ADDENDUM NO. 02

**PROJECT: Ossining Union Free School District
Park Early Childhood Center
Second Floor Classroom Addition**

DATE: September 29, 2023

CPL PROJECT NO: 14428.20

PES
C002

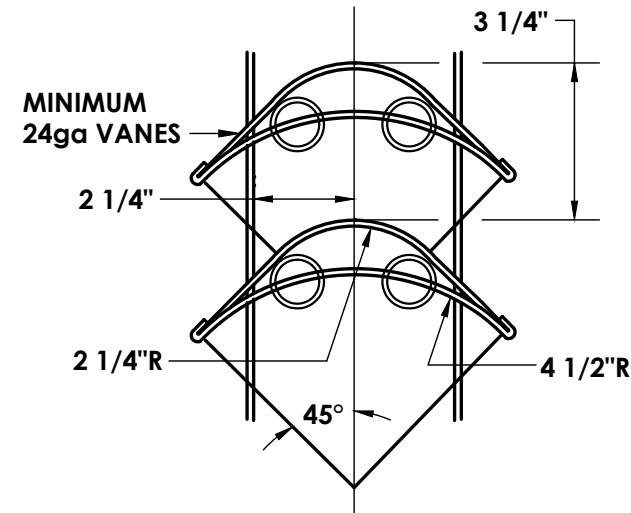
- 1.28 Drawing C002**
A. Replace existing C002 drawing with attached C002 drawing.

Answer: Review Staging and Phasing plan C001.
- 1.22** Question: Drawing E200 / Note 8 - Owner supplies cameras, is the EC responsible for installing?
Answer: Owner will be responsible for supplying and mounting the camera. The EC is responsible for providing a network drop from the IT closet to the location above the ceiling where indicated. Cable should be terminated and tested by EC. EC should coordinate the final location with the owner.

4 CONVECTOR DETAIL
H801 NOT TO SCALE

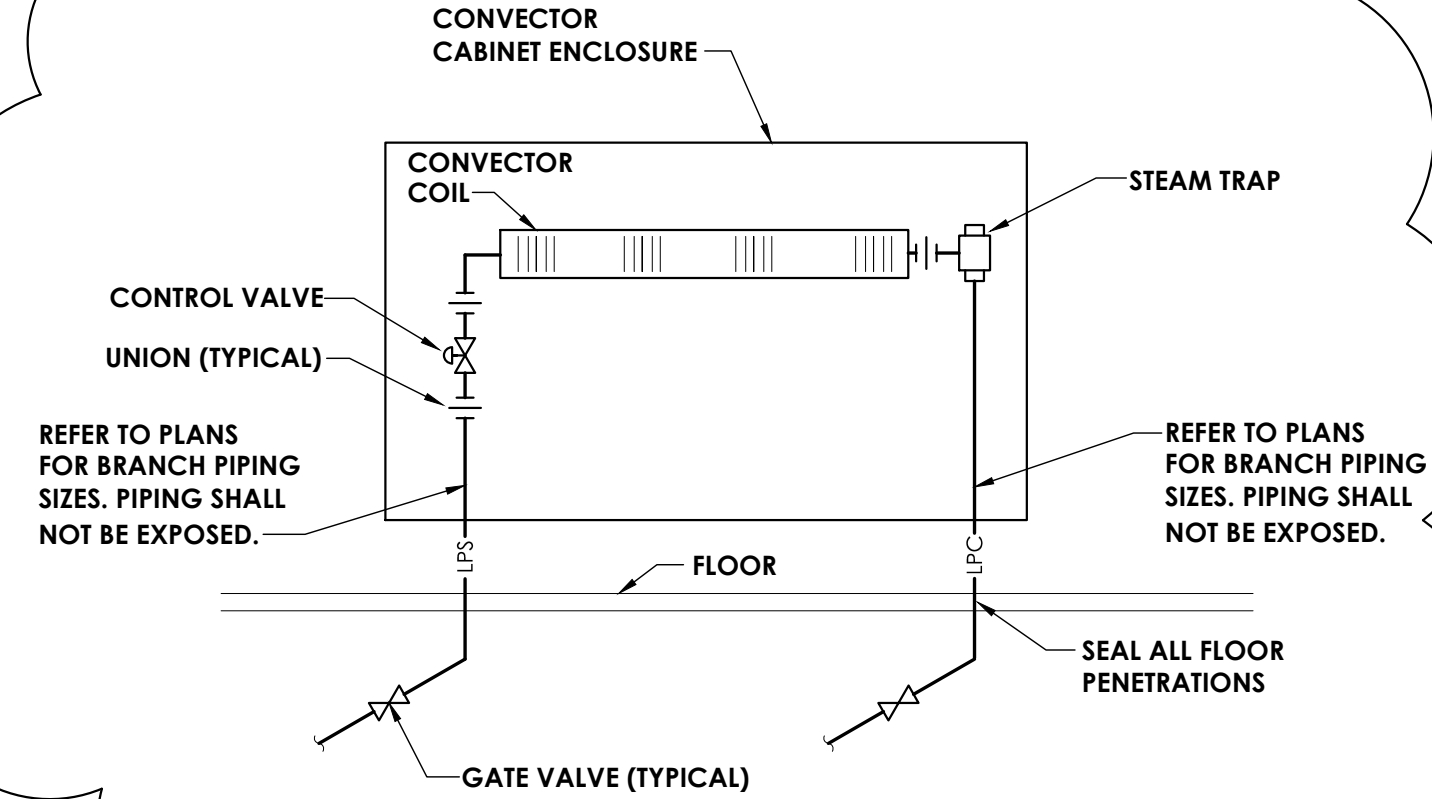
Answer: 1 hour
- 1.11** Question: Please advise of the steam trim requirements and detail associated with the steam convector.
Answer: Added steam convector detail to sheet H801.
